Service Kit

759-04144

Subject: Service Replacement for the
50" RZT Left Hand (LH) Hydro
Transmission

FIGURE 1

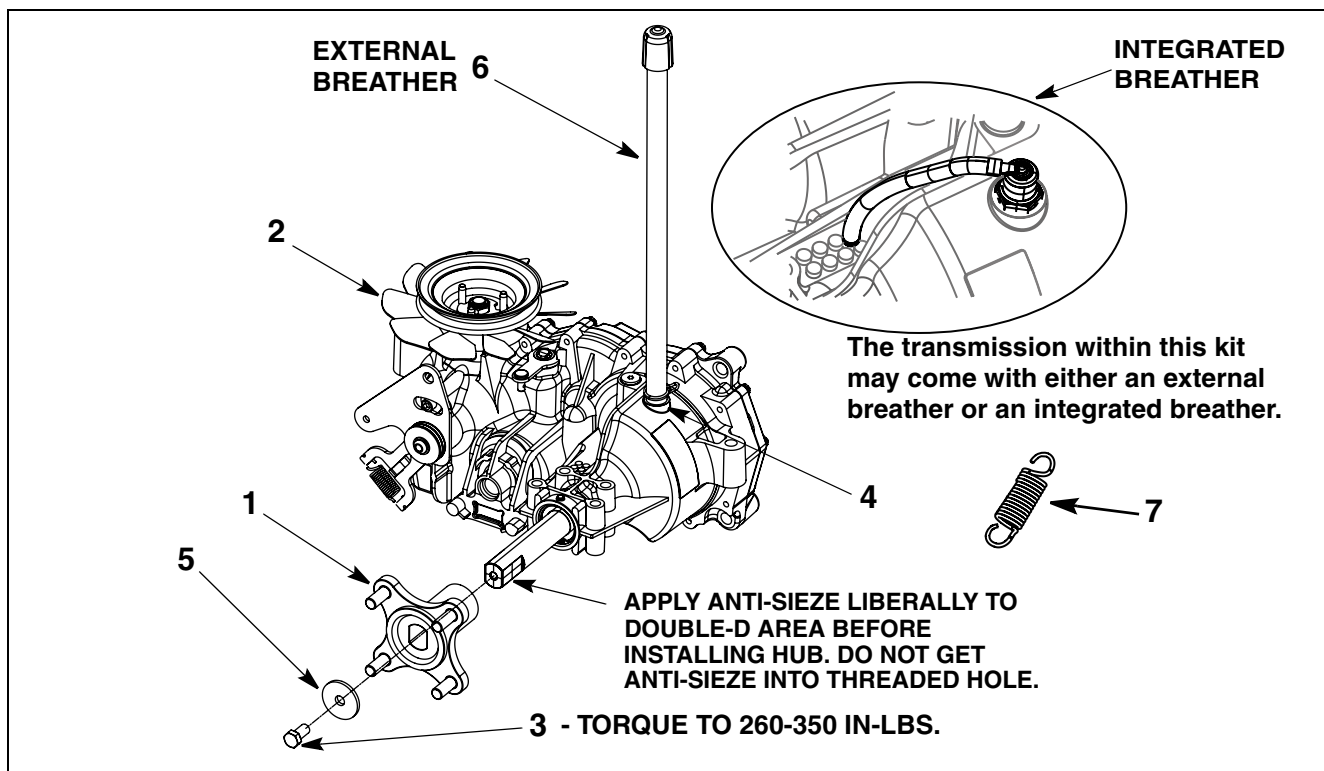
PURPOSE: This service kit replaces the LH hydro transmissions 618-04164A and 618-04327 which are no longer available. The replacement transmission has a Double-D axle end which requires a Double-D wheel hub assembly. A new neutral return spring is enclosed for the RH transmission. See instructions on page 2 of this sheet.

ITEM NO.	PART NUMBER	QTY	DESCRIPTION
1	618-04317	1	HUB ASM:WHL:DOUBLE-D LONG
2	618-04431A	1	TRANS ASM:HYDRO:EZT:LH
3	710-3119	1	SCREW:3/8"-16 x .750:GR5:LOCK
4	726-04059	1	CLAMP:HOSE: .750
5	736-0227	1	WASHER:FLAT: .390 x 1.50 x .134
6	751-10474	1	HOSE: BREATHER: EXTERNAL
7	732-04448	1	SPRING: EXTENSION (See page 2)
8	*	1	THIS INSTRUCTION SHEET
